## **Oro Hondo Fan Backup**

### **Questions & Answers**

Coms Line highlighted in yellow

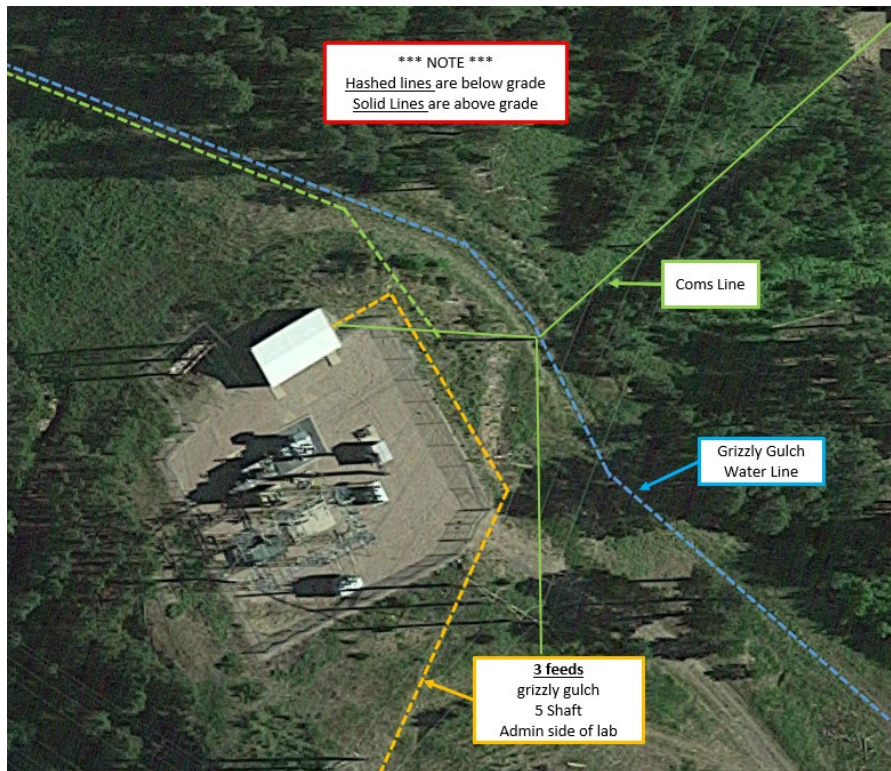
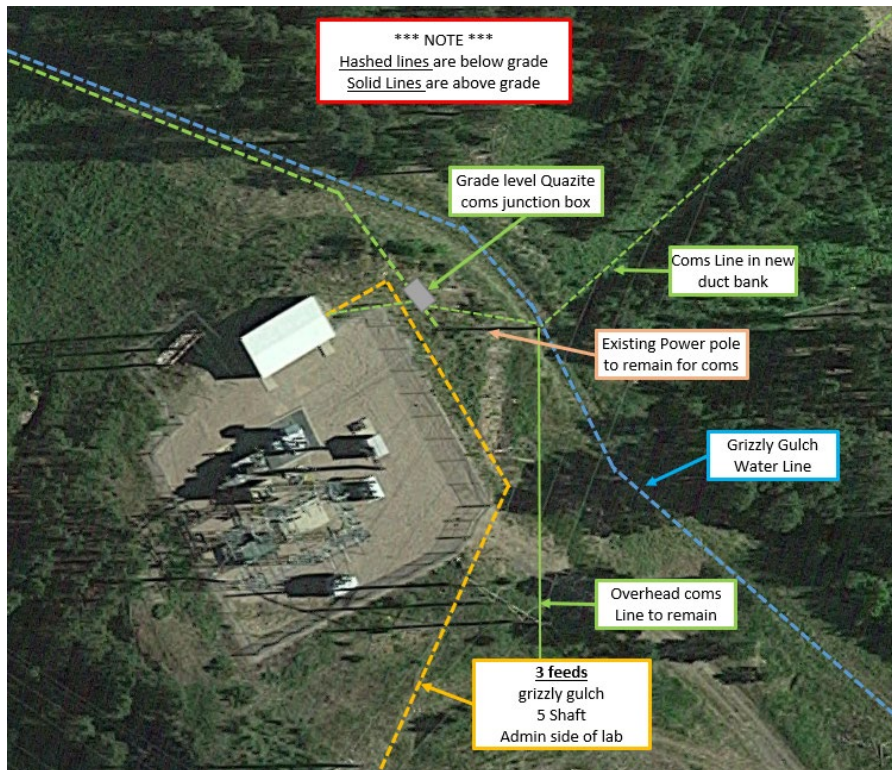
- 10) How should the overhead communication line be handled that runs overhead to the substation from the pole just outside the substation fence line?

Please see the graphics below. The overhead communication line coming from substation building to the power pole shall be installed according to bid documents with the addition of a grade level junction box on the bench just outside the perimeter fencing. The junction box shall consist of appropriately sized PVC conduit with PVC coated rigid galvanized conduit (RGC) elbows with a polymer concrete Quazite box rated for overhead traffic. The power pole outside the substation fence shall remain as a communication pathway for the other overhead

communications lines that are not part of this project. The power conductors and hardware shall be removed from this pole communication lines shall remain.

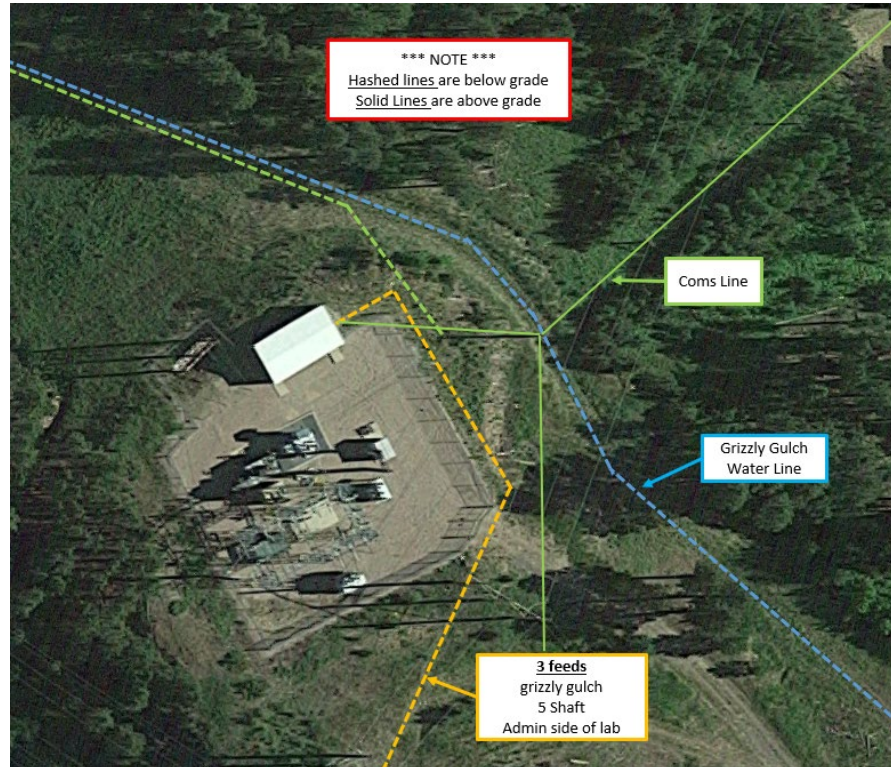
14) During the walkthrough it was found that there are 3 feeds of electrical lines and the Grizzly Gulch waterline that cross the path (below grade) of the planned duct bank location (see sketch below). After you review this can you provide some direction on the following:

Offeror's shall plan to field verify the depths and locations (during the design of the project) of the 3 electrical feeds, underground communication line and Grizzly Gulch water line to determine if the new duct bank path can go over, under, or around these lines. The Grizzly gulch water line has a 6ft bury depth. Offeror's shall field verify and adjust design accordingly for the new duct bank. The drawing below shows the approximate locations of these lines.
